Historic Preservation Board

Wednesday, November 15, 2023 at 5:00 PM

- i. Administrative Appeal of Certificate of Appropriateness for Alterations to Noncontributing Garage; 14 ORCHARD STREET; William & Jean Bennett, Appellants. Plan Number: HPAR-002615-2023.

**STAFF MEMORANDUM
HISTORIC PRESERVATION PROGRAM
PLANNING AND URBAN DEVELOPMENT**

A5 STREET / NORTH ELEVATION - OPTION A
REFERENCED FROM: SCALE: 1/4" = 1'-0"

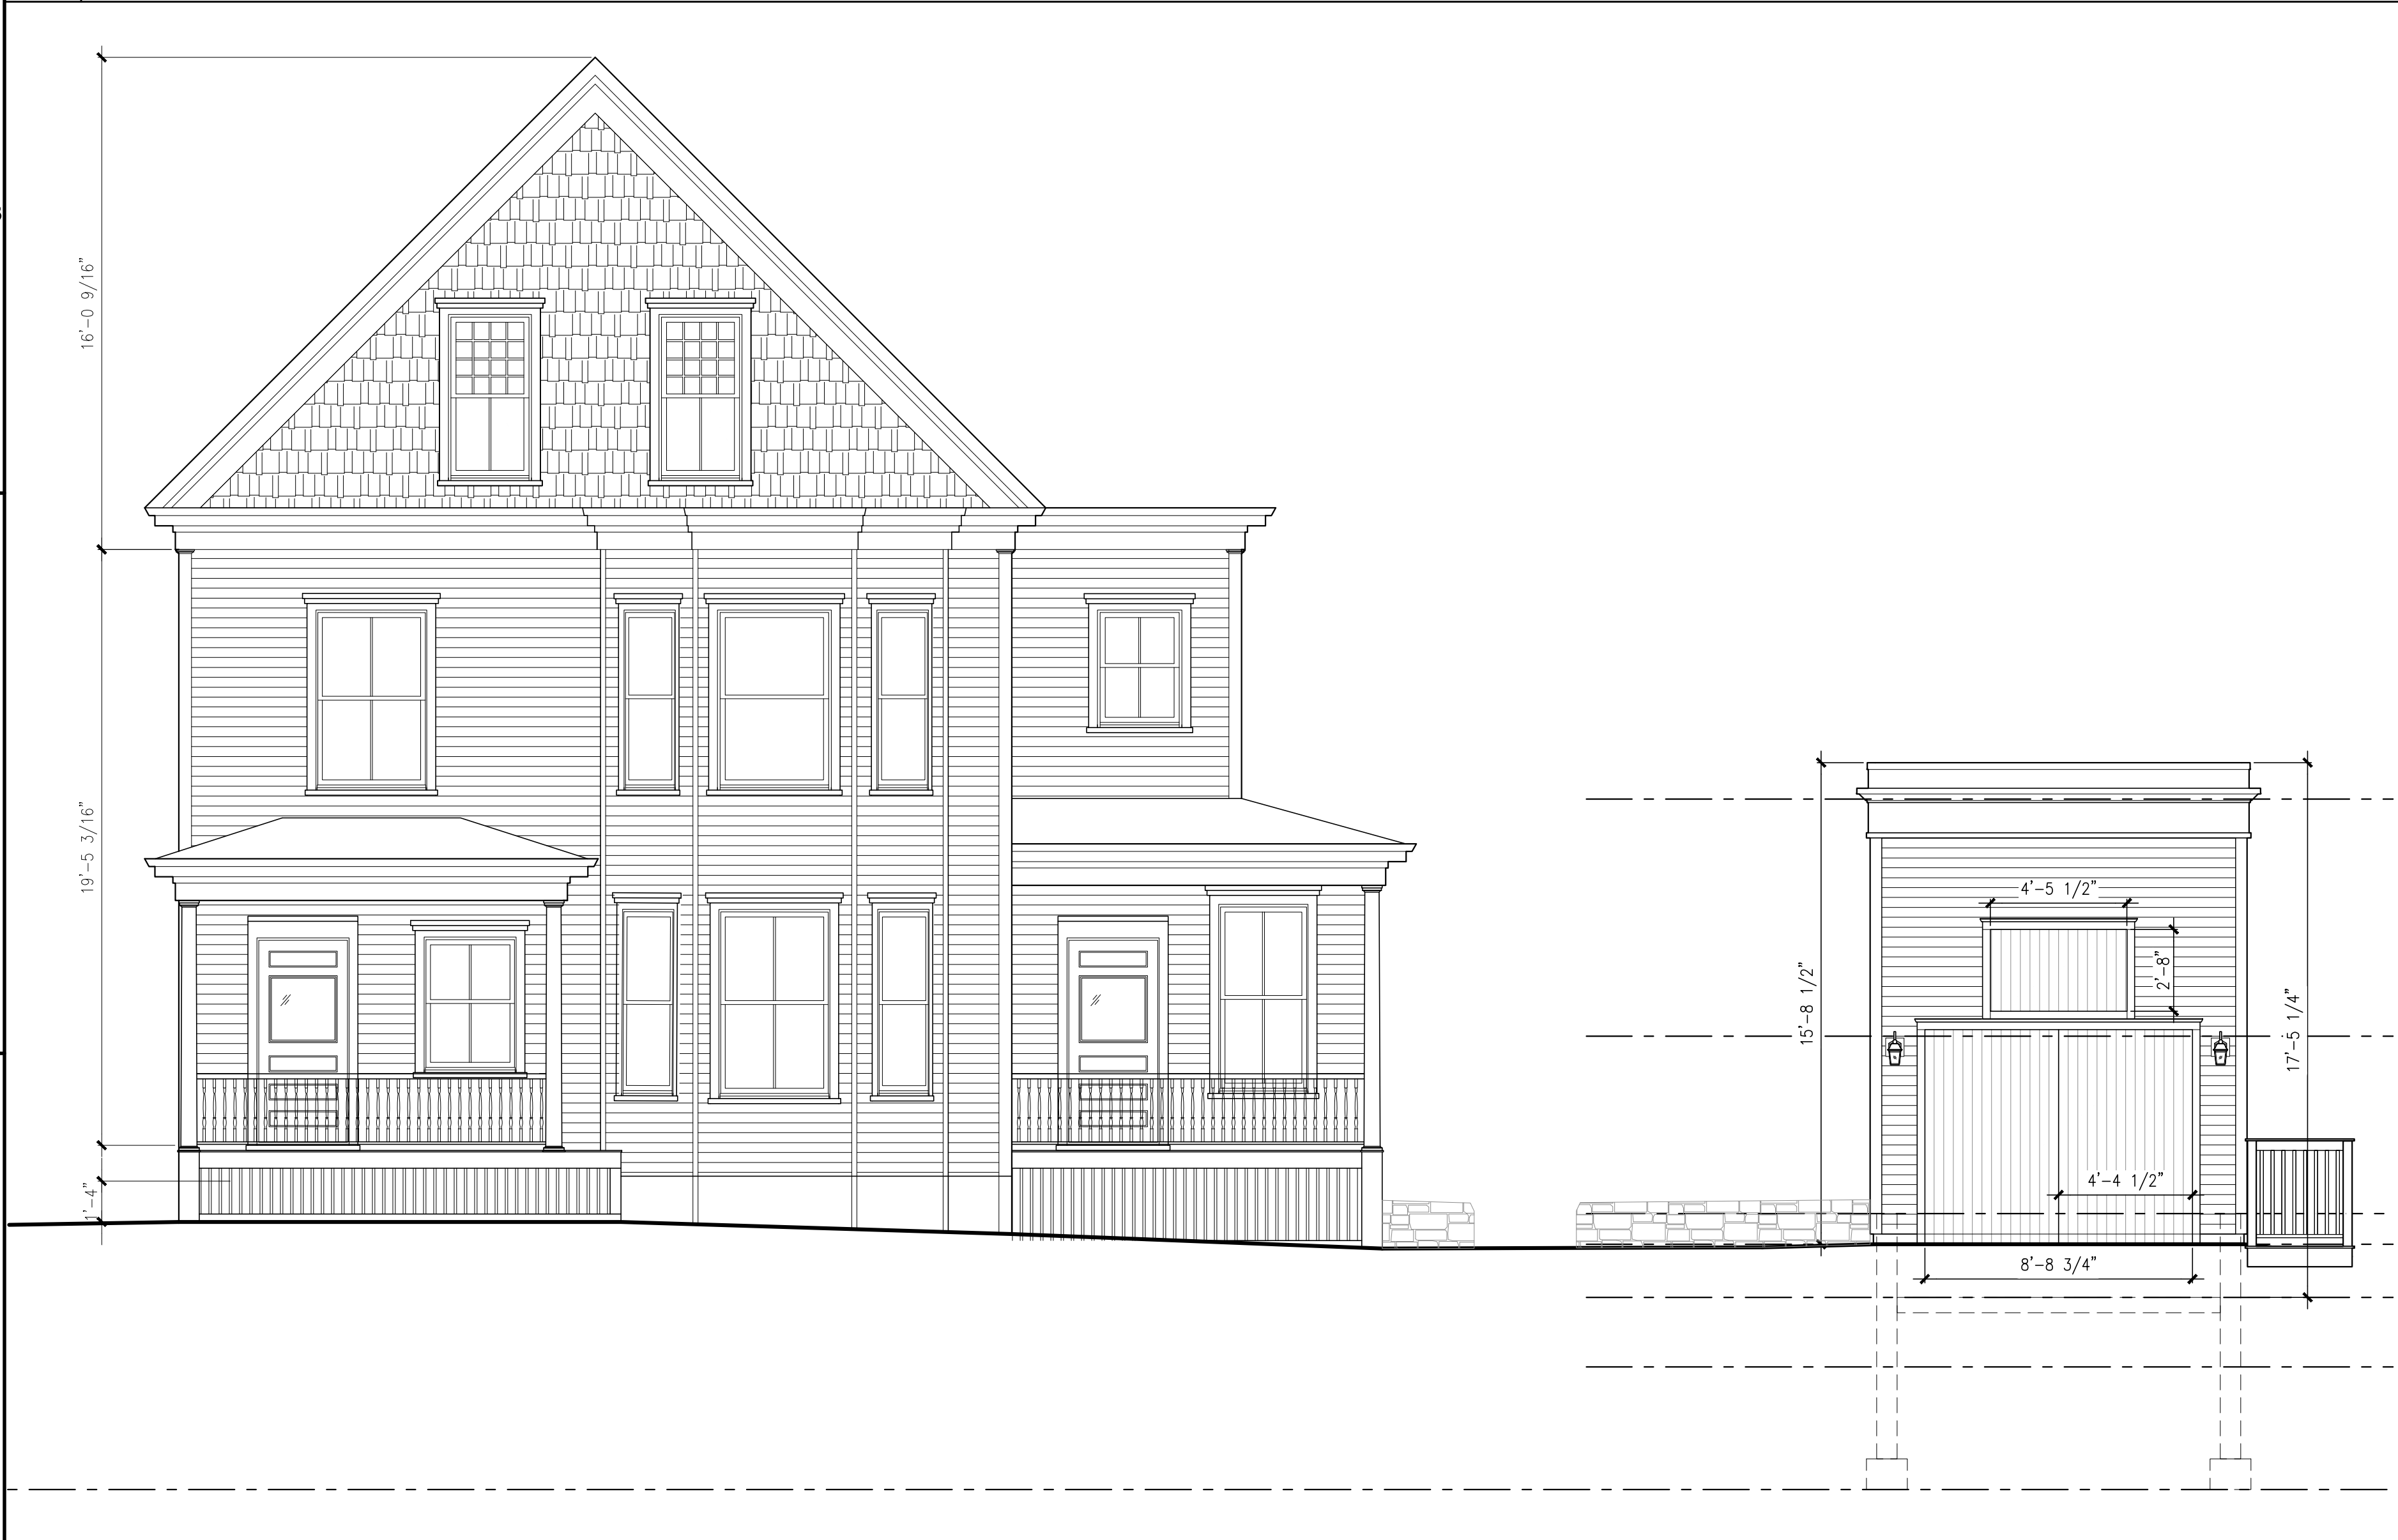
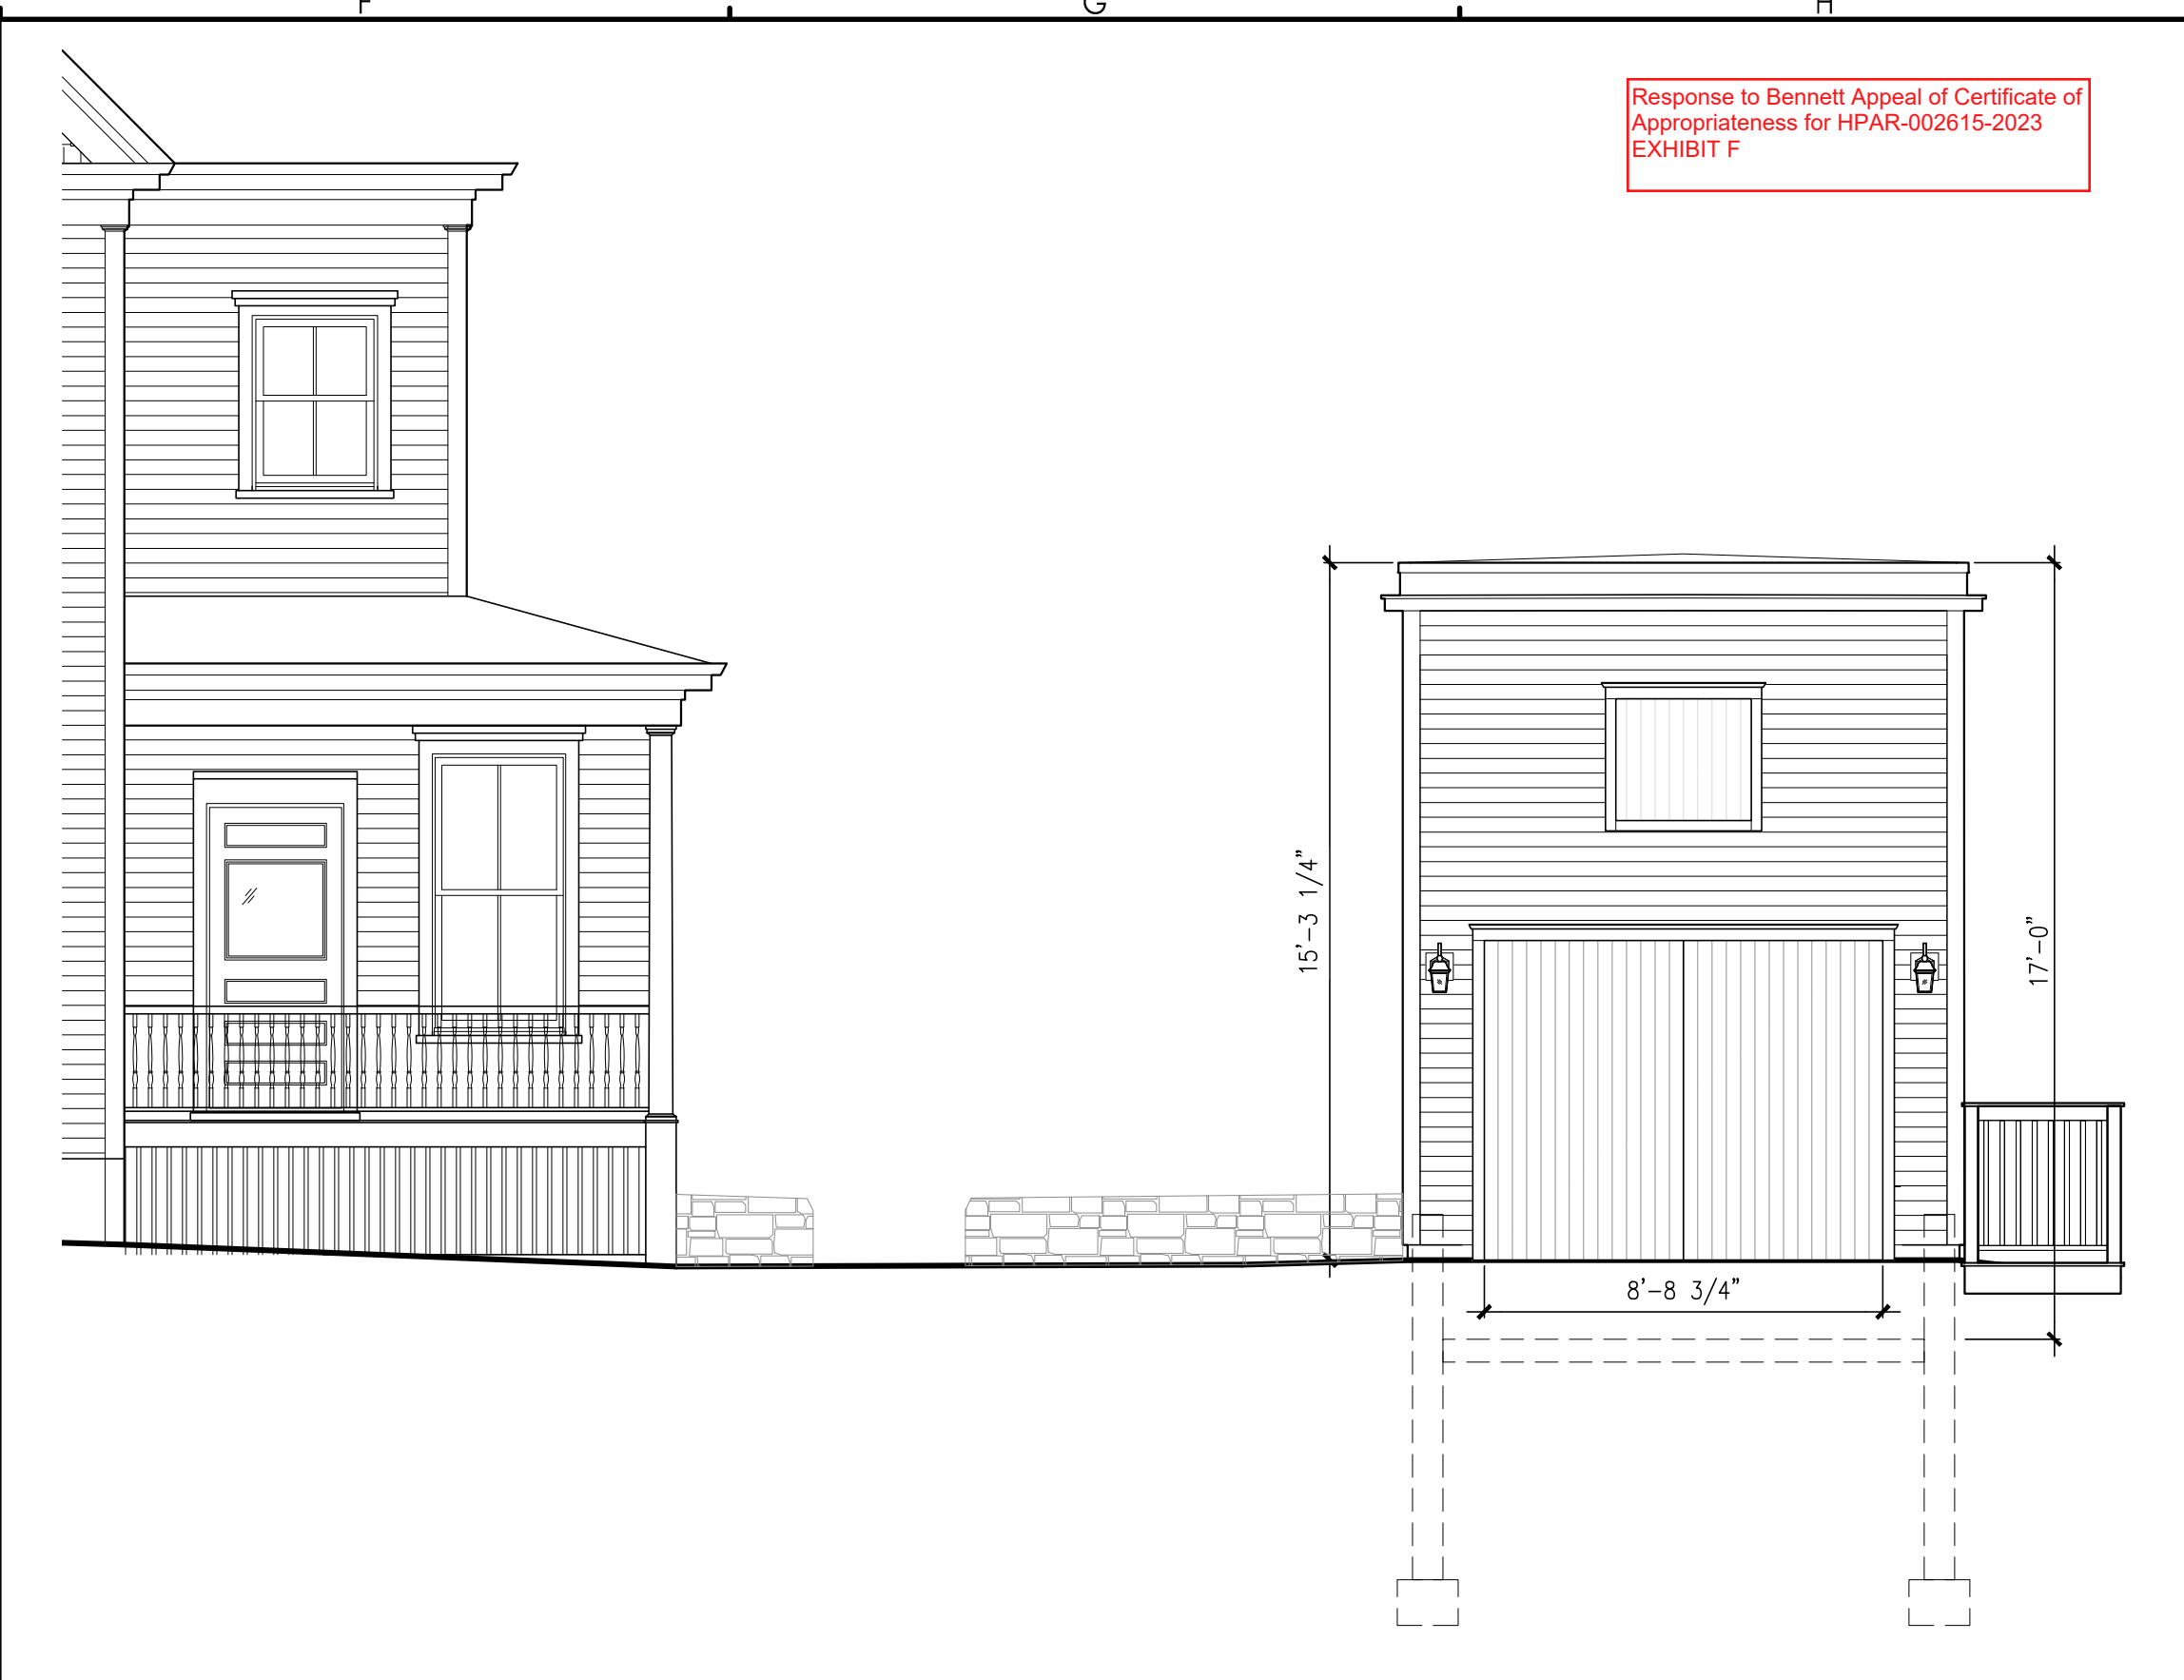
Attached you will find elevation sheet A3.10 ALT with options that include the comments below and window sheet A8.10 that has been revised to include trim details.
